COMPONENT CODE 54 PARTS & SERVICE REF NO. AT04812 DATE May 26, 2004 Page 1 of 7

SUBJECT: STRENGTHENED DRIVE SHAFT GUARD FOR HM300-1

- **PURPOSE:** To introduce strengthened drive shaft guard for use on HM300-1 articulated dump trucks
- **APPLICATION:**HM300-1Articulated Dump Trucks, Serial Nos. 1001 thru 1147HM300TN-1Articulated Dump Trucks, Serial Nos. 1001 thru 1002

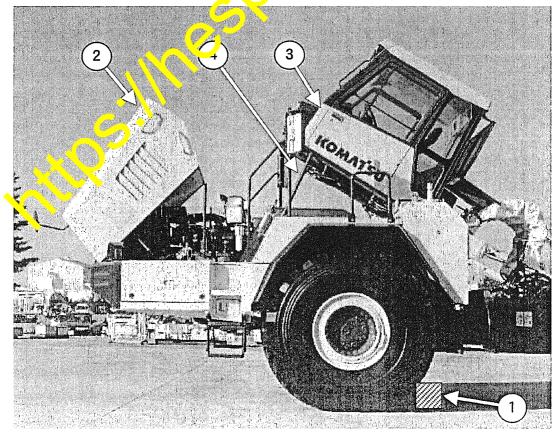
In addition to the current drive shaft guard, guard for the spider section has been added to realize a structure which can prevent the secondary damages of neighboring parts even when the drive shaft is broken. (Refer to Fig. 1.)

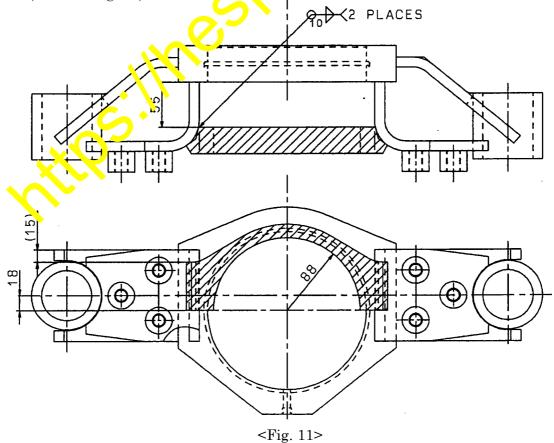
6. In case of strengthening the currently installed parts by reworking Being introduced below is the another method than the replacement of the parts to make this improvement by locally reworking the current parts to acquire similar improvement effects to the above Section 5.

6-1. Make the parts indicated below locally. (Refer to Fig. 10.)
